GOVERNMENT OF INDIA  
MINISTRY OF ENVIRONMENT & FORESTS  
**Central Zoo Authority**

**Sub:- Construction of enclosures for Common leopard, Clouded leopard and Wild boar at Biological Park, Itanagar.**

The design for the construction of enclosures for Common leopard, Clouded leopard and Wild boar at Biological Park, Itanagar were placed before the Meeting of the Expert Group on Zoo Designing of the Central Zoo Authority held on 12<sup>th</sup> December, 2011. The observations of the committee are given below:-

**DRWG NO** : WLS/CL/02

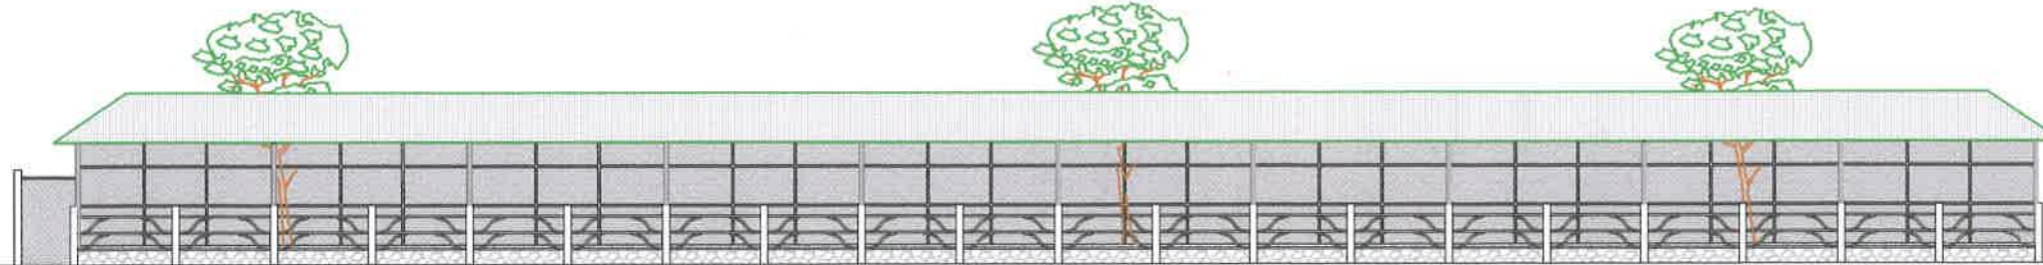
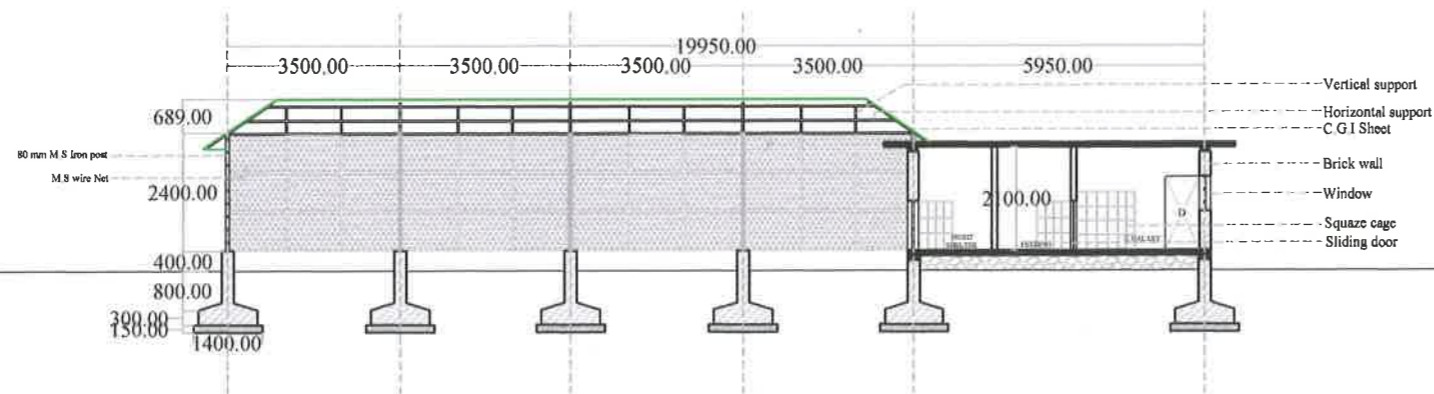
- a. The roof of the enclosure should be made doom type rather making it hut type structure.
- b. The housing facility for animals should have atleast six numbers of feeding and retiring cells, which should be located in such a way flushing towards paddock area in horizontal manner along the contour.
- c. There should be a keeper gallery of 2 meter wide.
- d. The keeper's gallery should have opening on both sides.
- e. The feeding and retiring cells should be interlinked with using sliding doors as partitions.
- f. The one side of feeding cell should have a provision of a squeeze cage.

- g. The feeding and retiring cells should be located of atleast 2 meter high from the ground level with proper drainage system.

Keeping in view of the above, revised design should be submitted to the Central Zoo Authority for records. A copy of the design, indicating the necessary changes may also be forward to the Zoo Director for carrying out necessary amendments.
